Loose Windshield Dam at Lower Right Corner of Windshield

Service Category Vehicle Interior

Section Interior Panels/Trim

Figure 2.

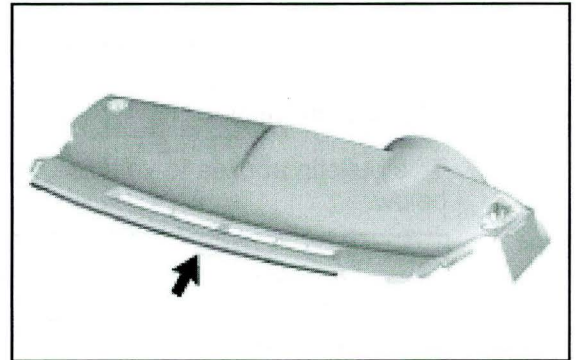
2. Remove the Instrument Panel Cushion.

HINT
Remove excess glue that remains.

3. Install the NEW Instrument Panel Cushion.
